Addendum No.3
to
CONSTRUCTION DOCUMENTS
for

NCISD New District Administration Building
21330 Valley Ranch Parkway
New Caney, TX. 77357
June 2, 2025

Below is a summary of the sheet and specification revisions for Addendum #3.

3 MECHANICAL ENLARGED PLAN - LEVEL 2 - UNIT C - MECH/ELEC D265
Scale: 1/4" = 1'-0"

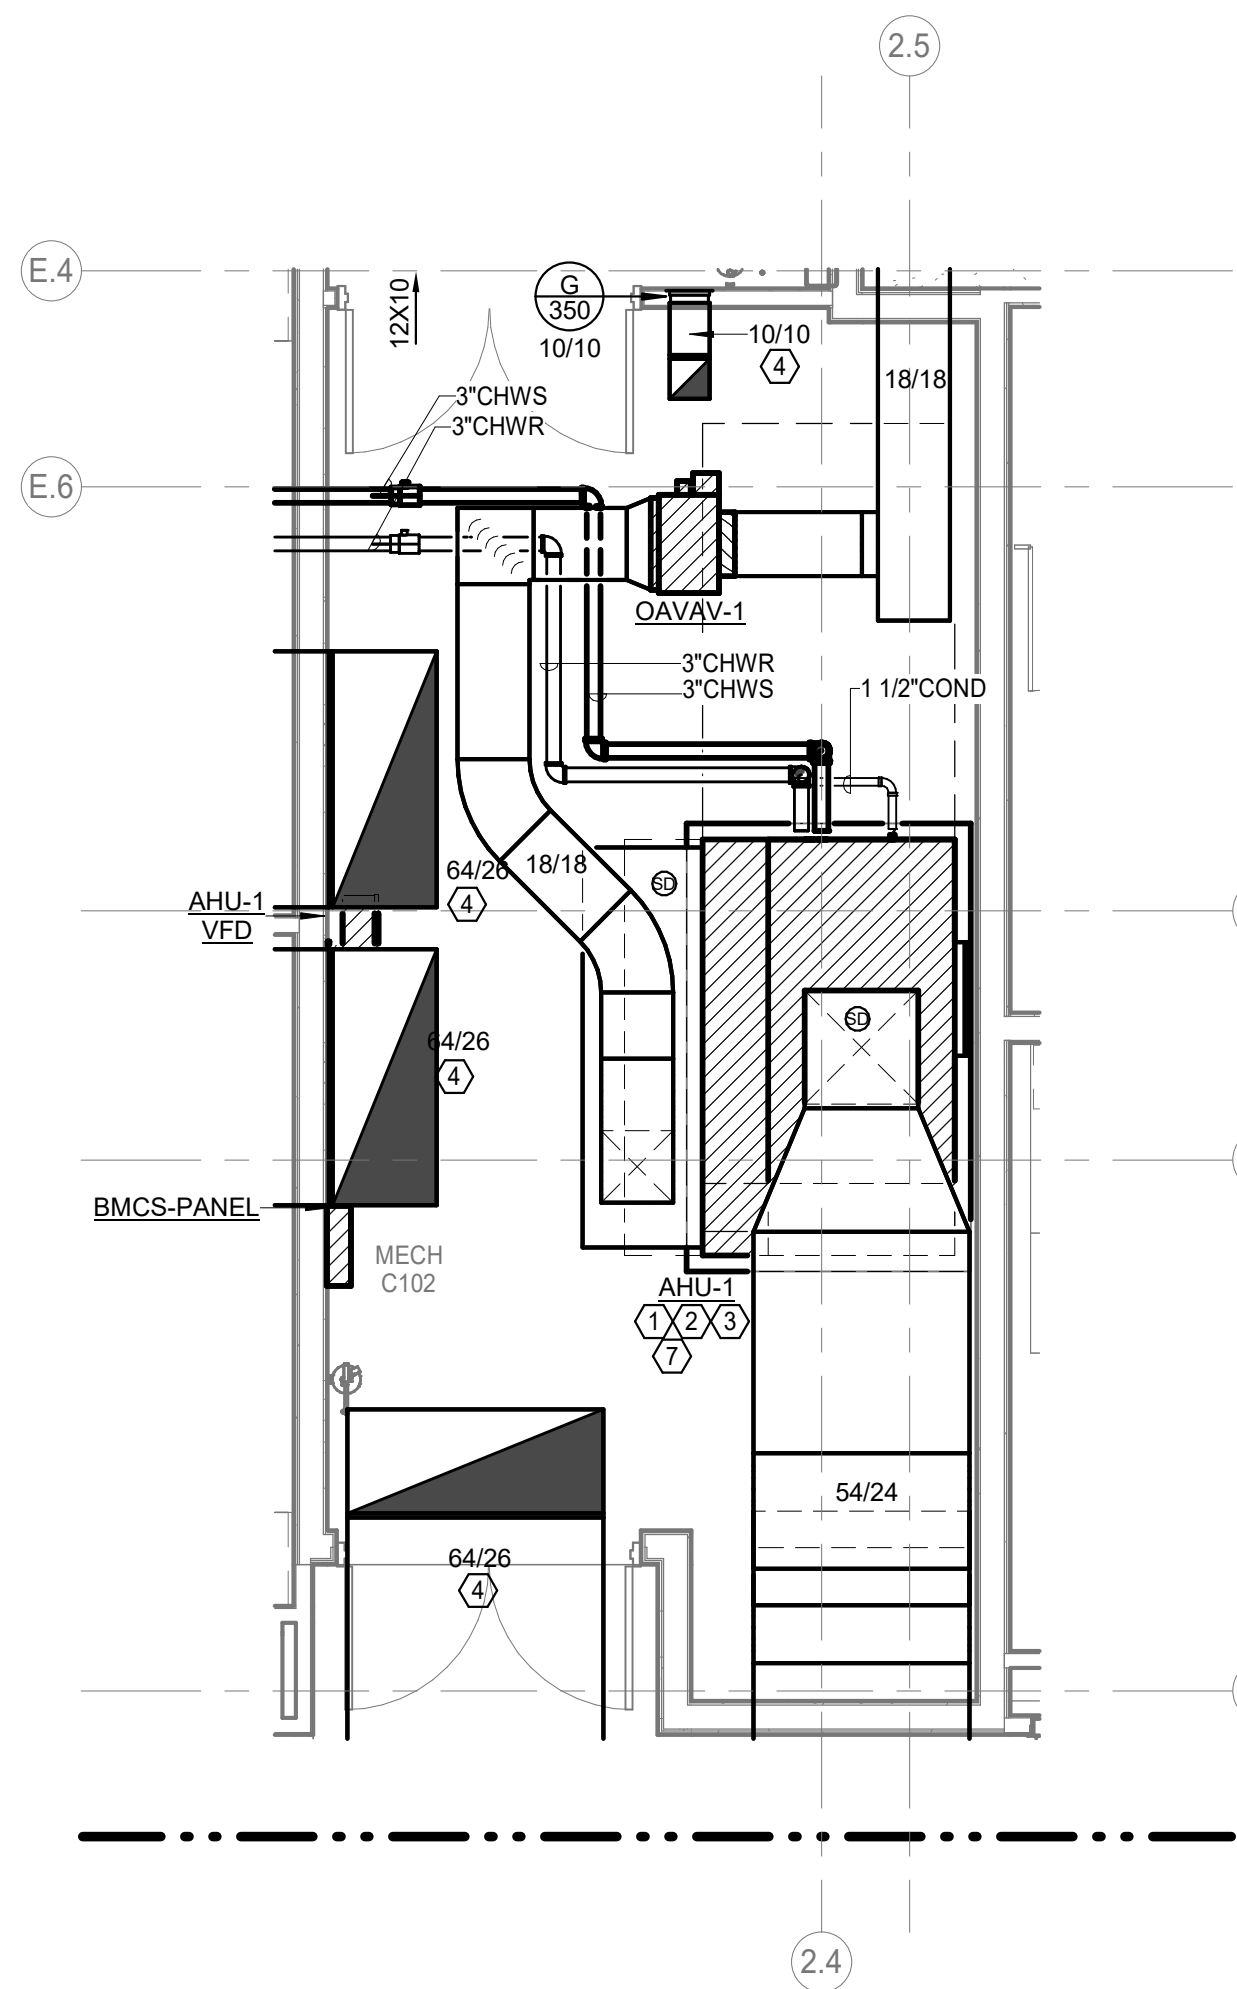
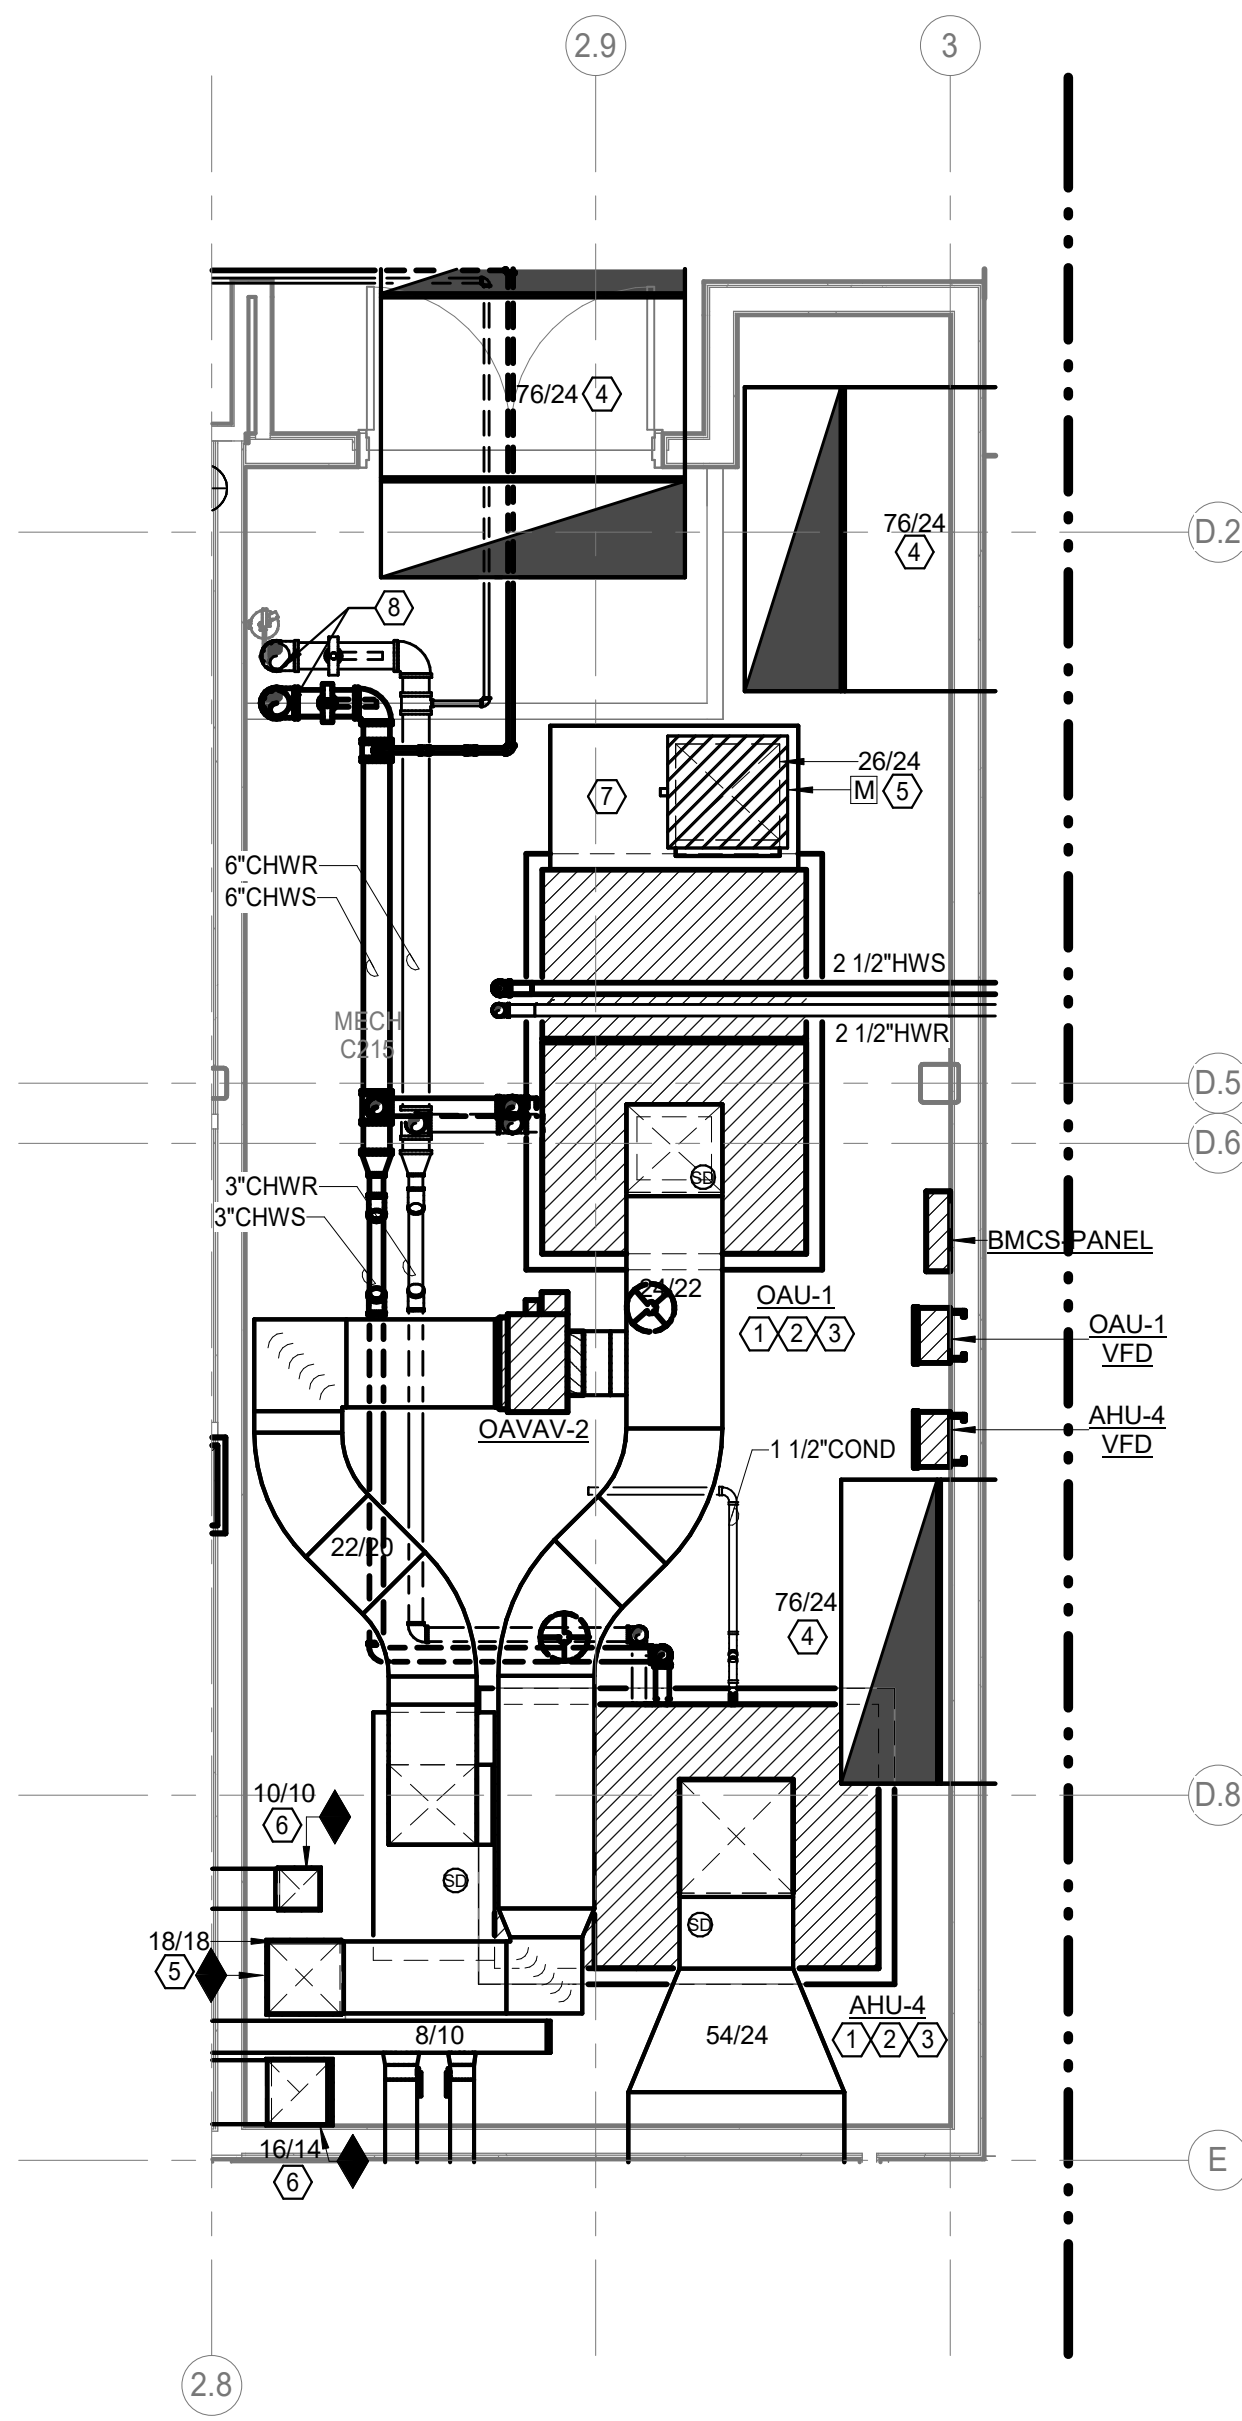
7. SHEET M-118 – MECHANICAL ROOF PLAN
 - a. Revise location of EF-10 to reflect updates from sheet M116-F2. Refer to sheet.
8. SHEET M-202 – MECHANICAL SECOND FLOOR AREA – F2

- a. View #3: Add elbow sound attenuator in ductwork served by AHU-5.
 - b. View #4: Add sound attenuator in ductwork served by AHU-6.
9. SHEET M-501 – MECHANICAL SCHEDULES
